Road Rail Vehicle National Project – Human Factors Observations

The ONRSR National Priority Project for RRV Safety was undertaken in response to these incidents and, in recognition of the above concerns, Human Factors observation was included as an adjunct to the present round of RRV safety compliance inspections.

Figure 12. Close-up of Figure 11 showing close proximity of controls adjacent to single RGS control. The potential for inadvertent activation of adjacent switches is clear.

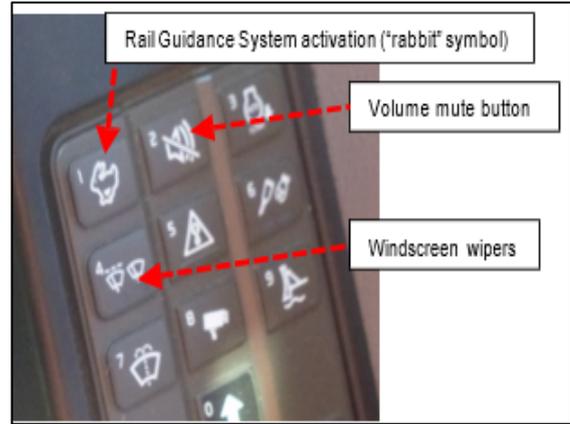
Figure 11. Copy of Figure 2 showing close proximity of numerous soft-key press-buttons for differing functions. See Figure 12 (at right) for close-up.

Figure 13. Interior Emergency Stop push-button: located low on the right cab interior wall; well outside driver's primary visual field.

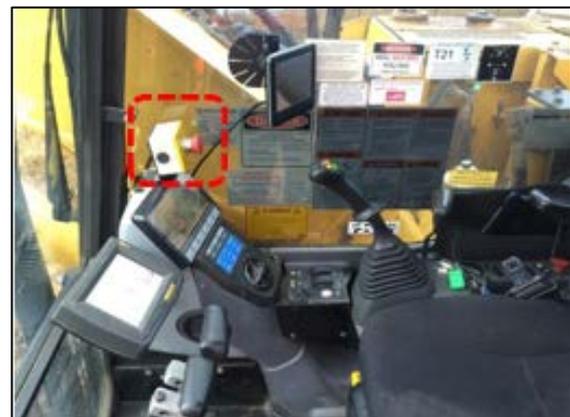
The location of the Emergency Stop Button (ESB) varied between vehicle types. This presents a significant safety risk because the conditions under which a driver may have to activate an ESB are, by definition, emergency conditions when human response time is critical.

Figure 23. View of stickers on right-side cab window.

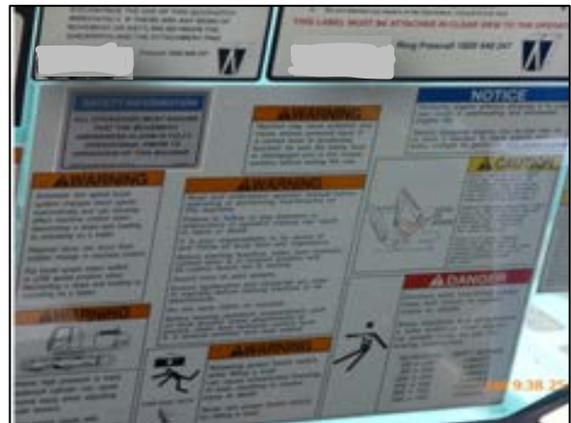
Most of the RRVs inspected featured an excessive number of information stickers placed over a significant portion of the available window space (see Figures 23 – 26). These stickers featured compelling title words such as “Warning”, “Danger”, “Caution”, “Notice” and similar.

That comment succinctly highlights the main issue. Examination of the excessive number and ad-hoc distribution of these stickers about the cab show that it would be unrealistic to expect an RRV operator to be able to quickly find a sticker related to any one particular issue.

In addition to the display of in-cab signage being ineffective (as noted in 4.2.3 above and in Figures 23 – 26), it presents a significant amount of visual clutter in the various operating fields of view of the driver.

Figure 28. Excerpt from an articulated dump truck manual. The photograph shows the pivot lock bar (arrowed) in the horizontal locked position (cf. Figure 30 [the same view] where the bar is clearly not in the locked position).

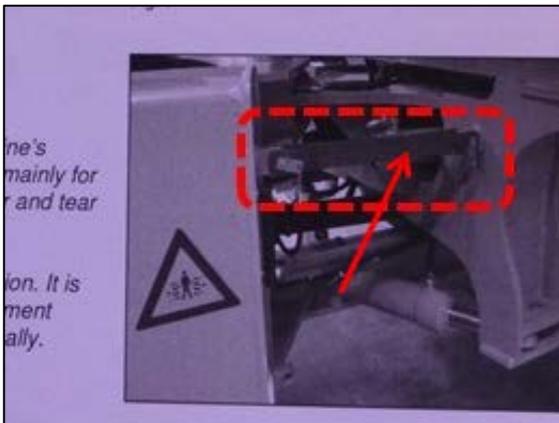
RRV operators operating articulated dump trucks stated that they believed it was important to *not* affix the pivot joint lock when travelling in rail mode as, they stated, it was important to be able to steer the vehicle slightly when encountering significant curves in order to not risk derailment and excessive wear.

By contrast, the equipment manual for these trucks explicitly stated that the pivot joint lock must "*always*" be mounted when driving on the rails "*for safety reasons*" and also to "*prevent excessive wear*" (refer Figures 28 – 30).

The manual and the RRV operators' beliefs are clearly in direct contradiction. The RRV operators stated they based their operating behaviour on experience with the equipment. By contrast, the basis for the instructions in the manual are not known.

Figure 30. View clearly showing the pivot lock (red bar) not locked in place. The RRV was on the rails at the time. Notably, the pivot lock bar appeared new and showed no indication of use.

Figure 31. Essential information regarding the safety-critical instructions for steering wheel position and avoidance of steering appears only in an inconspicuous paragraph in the Operating Manual for the RRV.

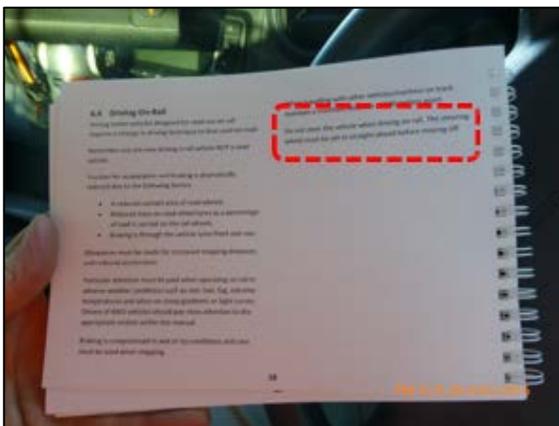
Although a seemingly important safety-critical requirement to prevent potential for derailment, this instruction is quite inconspicuous, only appearing in normal text and not until page 18 of the Manual (see Figures 31 – 32).

Figure 33. Example of other important information being conspicuously highlighted in the Operating Manual.

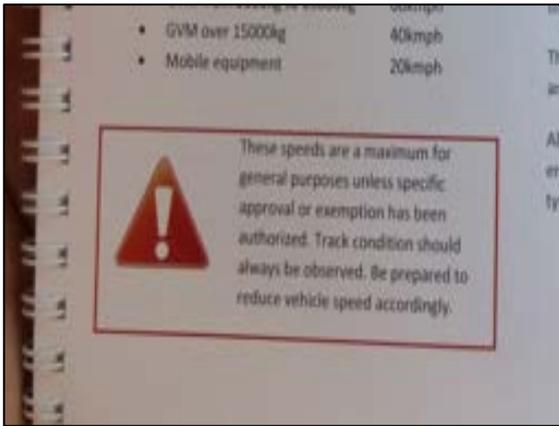
- > Other important information related to vehicle operation has been conspicuously highlighted throughout the manual (see Figure 33 for example) or placed on stickers on the windscreen close to the driver's line of sight (Figure 34). However, the essential instruction about the steering wheel position while on the rails – arguably one of the more important concerns prior to, and during, rail operations – receives only cursory and inconspicuous attention.
- > There is no design feature that could lock or stabilise the steering wheel in the straight-ahead position to eliminate the potential for inadvertent or erroneous movement of the steering wheel resulting in derailment.

Figure 35. An image from the articulated dump truck RRV Operating Manual showing an RGS switch configuration entirely different to that which was installed (see Figure 36).

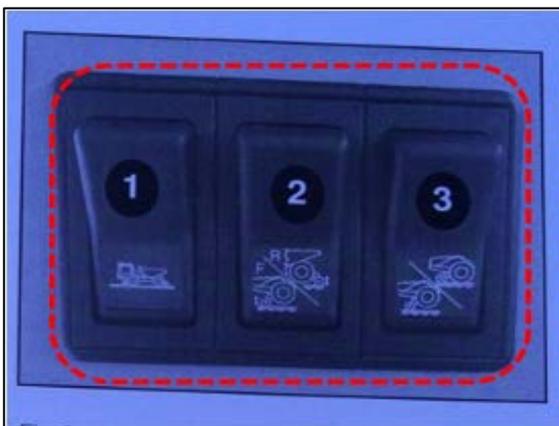
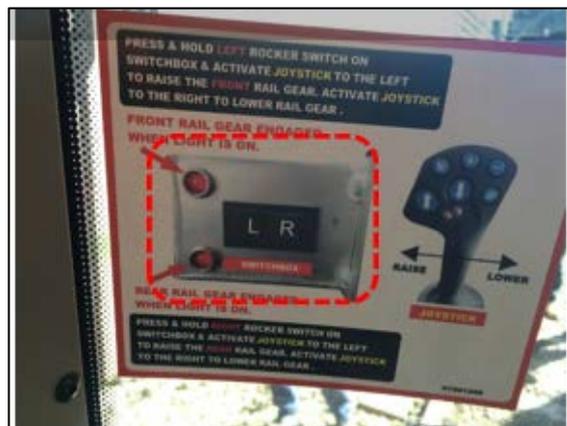
One RRV which was relatively new, had an operating manual containing instructions for a RGS that was entirely different to that actually installed in the vehicle (see Figures 35-36).

Figure 36. An instruction sticker in the same RRV showing the actual RGS controls. These are completely different to those shown in the Operating Manual held in the vehicle.
